FLOOR PLAN — NEW METAL TRAINING BUILDING (ALTERNATE) REV B

PROJECT	PHASE	SHEET TITLE	SCALE	DATE	REV	DRAWN BY	SHEET
Hazel Green Regional Athletic Complex **Hazel Green HS · Phase 1 alternate: new metal training building**	**PHASE 1 ALTERNATE**	**FLOOR PLAN** **METAL BUILDING (ALT.)**	**3/32" = 1'-0"**	**October 2026**	**B**	Drawn by KEYSTONE (AI) for Shane Brazelton	**P1-A-201**

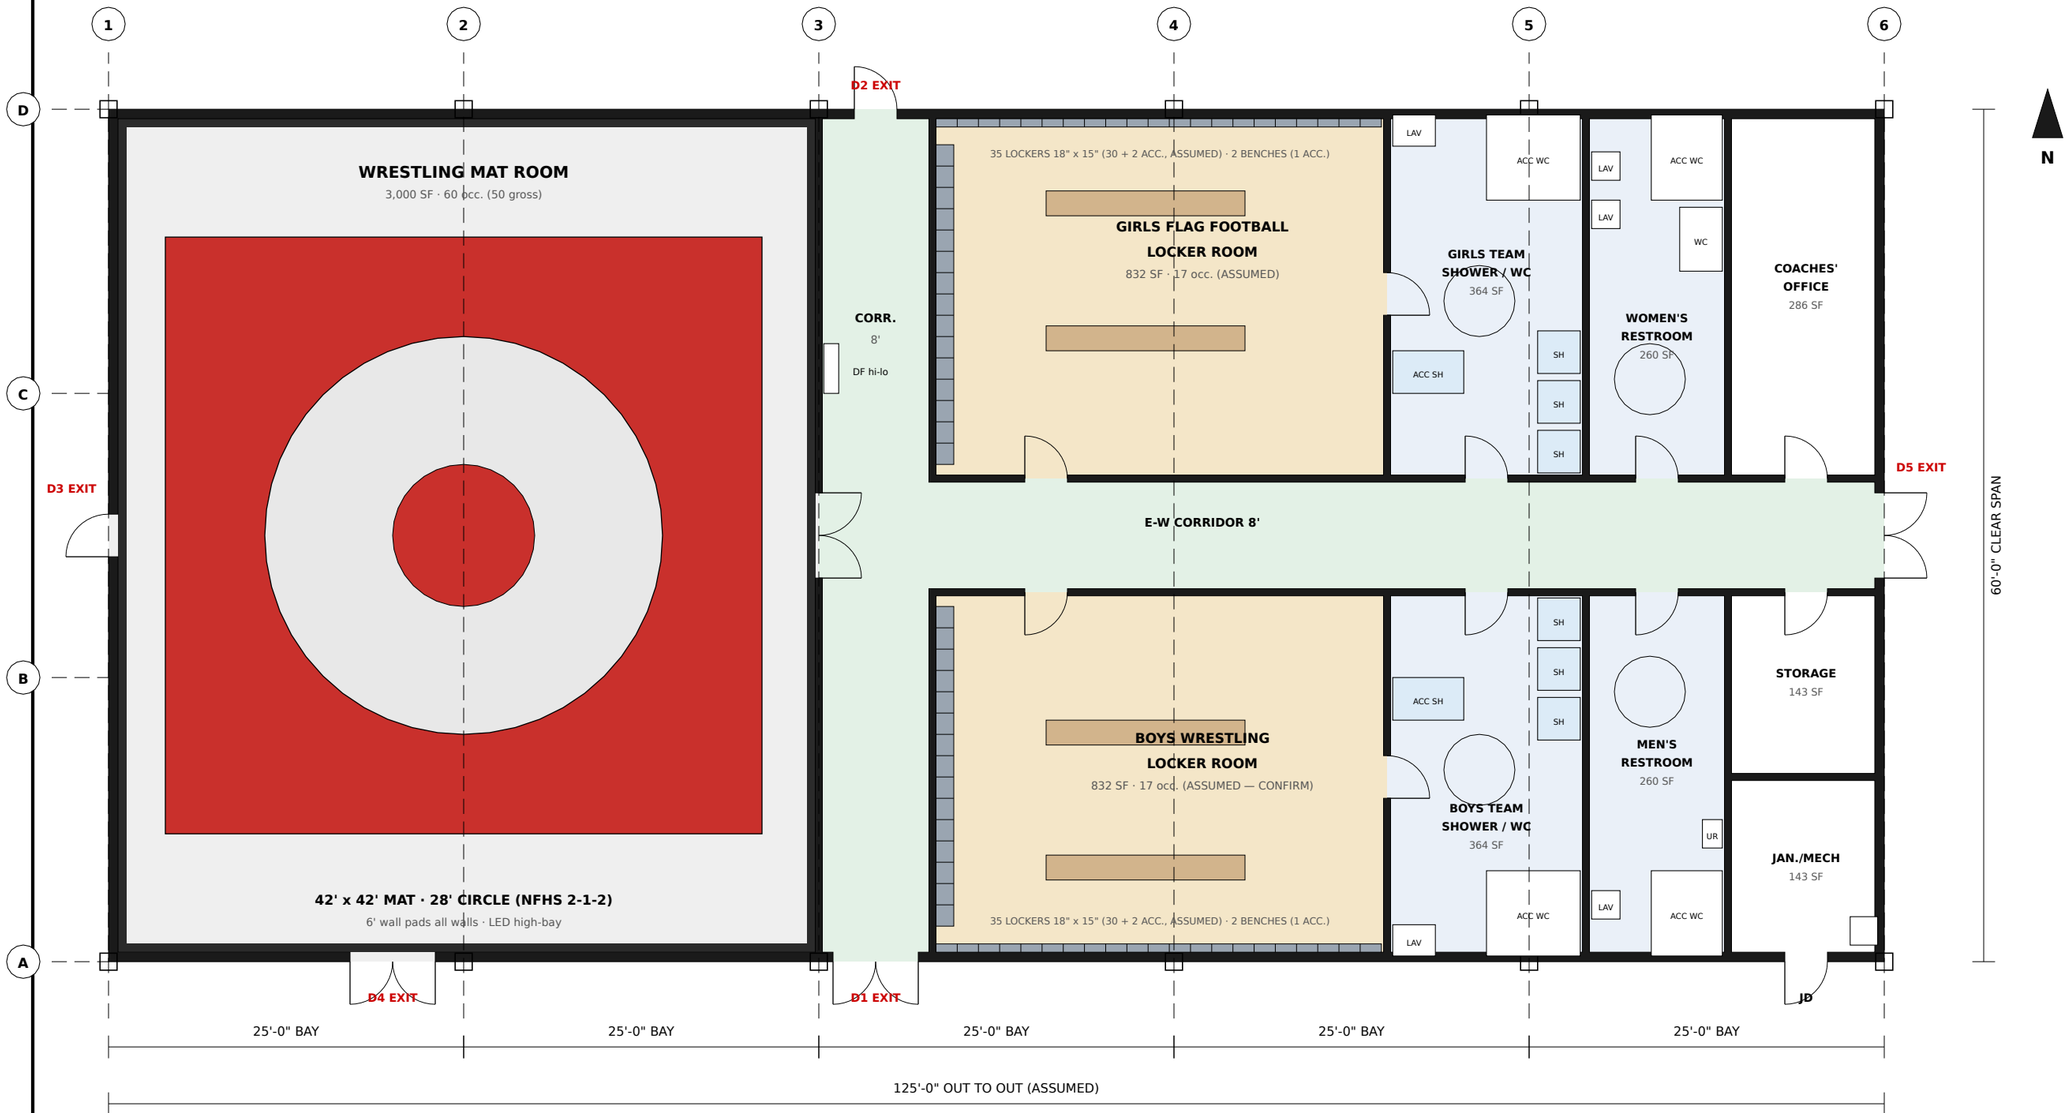
- D-095 (Shane 2026-10-15 5:12 AM CT) supersedes the D-094 layout: restrooms open off the corridor; 2 locker rooms, each with its own showers.
- Grown one 25' bay: 60' x 100' -> 60' x 125' (ASSUMED). Mat room unchanged: 42' x 42' mat, 6' pads.
- North: girls' flag football locker room (ASSUMED). South: boys wrestling locker room (ASSUMED — CONFIRM: Shane wrote 'boys lockeroom and boys locker room for wrestling').
- Team shower / WC rooms: doors from the locker room AND the E-W corridor. Women's + men's restrooms open only off the corridor.
- Privacy vestibules / door hardware at the corridor doors TBD (architect).
- Exits (red): D1 main pair, D2 N, D3 W, D4 mat pair, D5 E corridor pair. Checks: P1-G-101.
- Wet walls TBD (CMU or moisture-resistant). Cost TBD per the Summertown Metals quote.
